BEQ F, G & H - PHASE IV HVAC RENOVATION

BEQ F, G & H - PHASE IV HVAC RENOVATION

COVER SHEET

2 BLDG. F - PARTIAL 1ST THRU 3RD FLOOR PLANS ~~SOUTH~~ - DUCTWORK
NORTH
Scale: 1/8" = 1'-0"

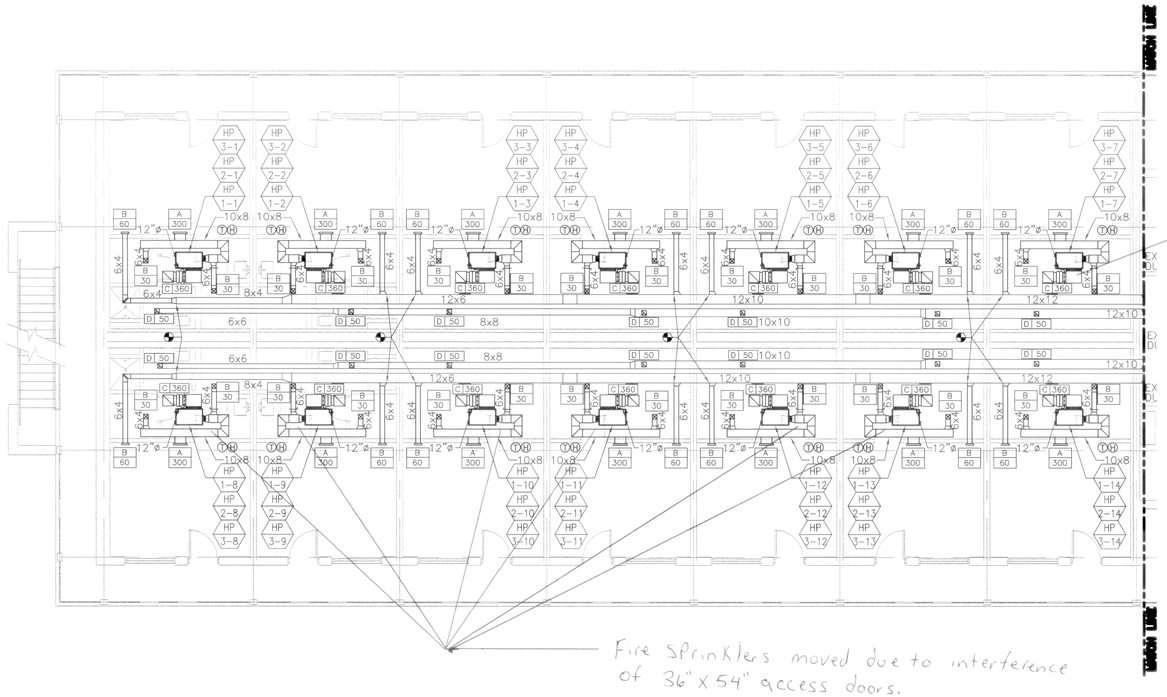
Used 6" diameter rigid in lieu of 6"x4" Rectangular.
Typ. F, G, and H Barracks
RFI #001

Fire Sprinklers moved due to interference of 36"x54" access doors.
RFI #009

1 BUILDING F – PARTIAL ATTIC PLAN – PIPING
Scale: 1/4" = 1'-0"

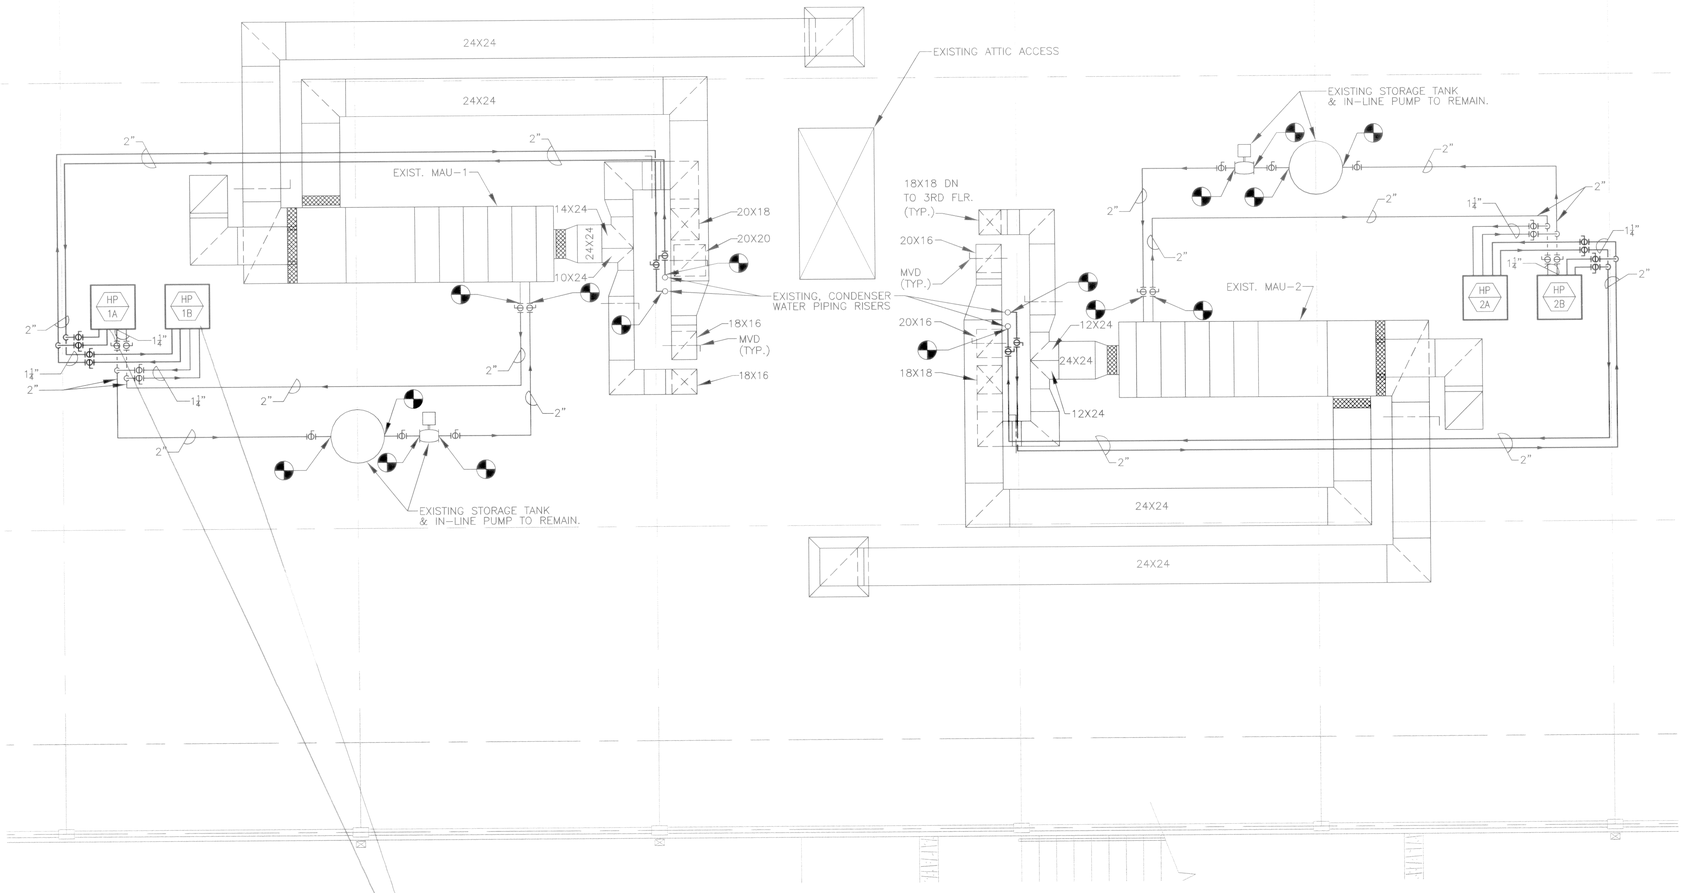
Installed "Soft Start" and flex hose connections at all attic pumps. Typ F, G, and H Barracks
RFI #007

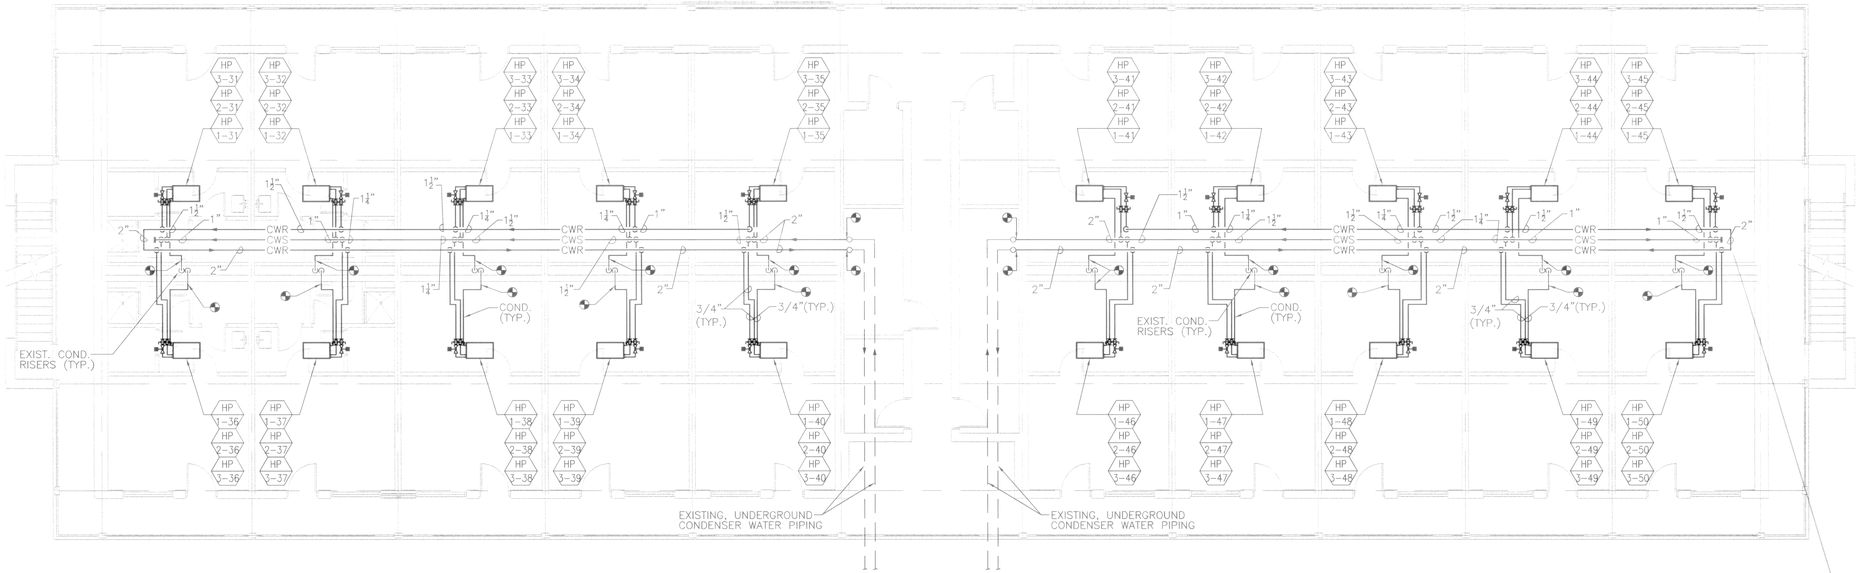
RFI - RFV 005 - Removal of CPVC in attic Spaces
Installed 1½" HDPE to the active system

2 BUILDING H - 1ST THRU 3RD FLOOR PLANS - PIPING
Scale: 1/8" = 1'-0"

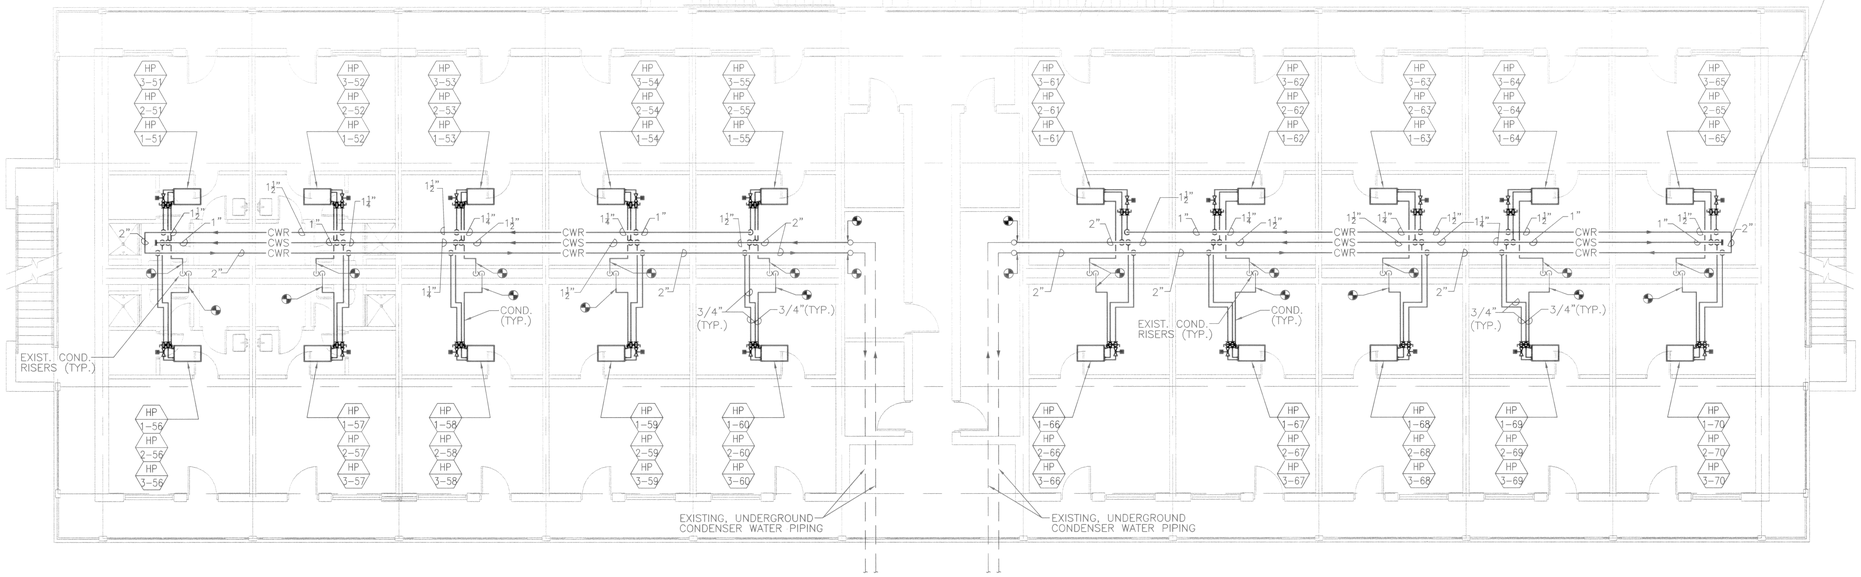
RFI 001
RFV
Changed Pipe Size from 2" to 1½"

1 BUILDINGS G & H – PARTIAL ATTIC PLAN – PIPING
Scale: 1/4" = 1'-0"

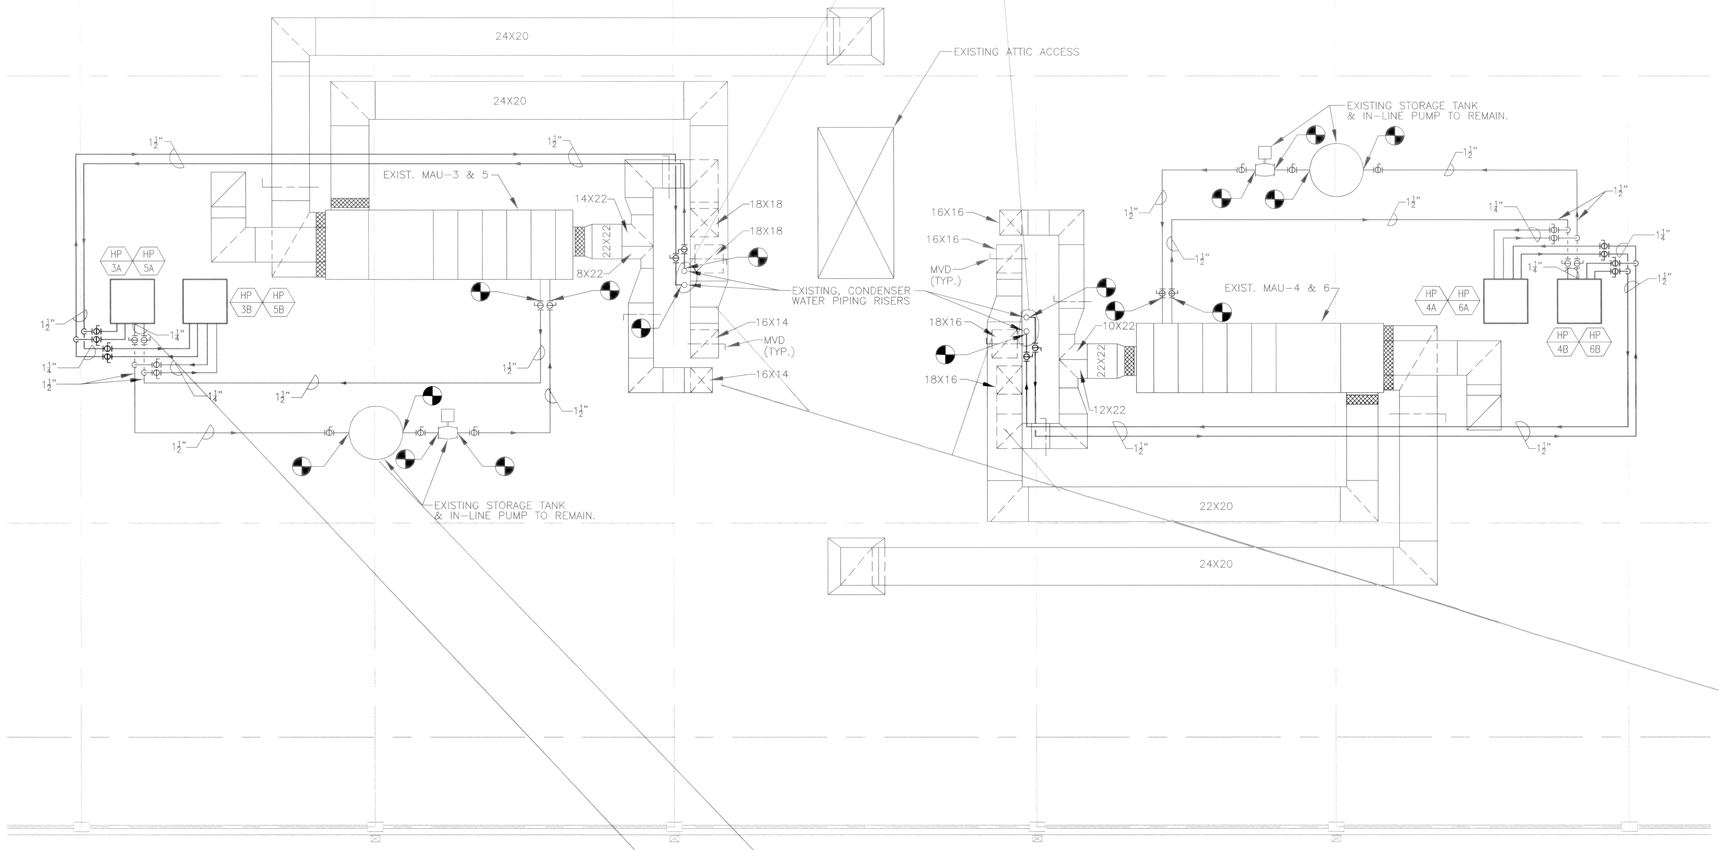
Provided insulation around duct.
Typ. F, G, and H Barracks

Installed 2" Insulation around Storage tank. Typ. F, G, and H Barracks
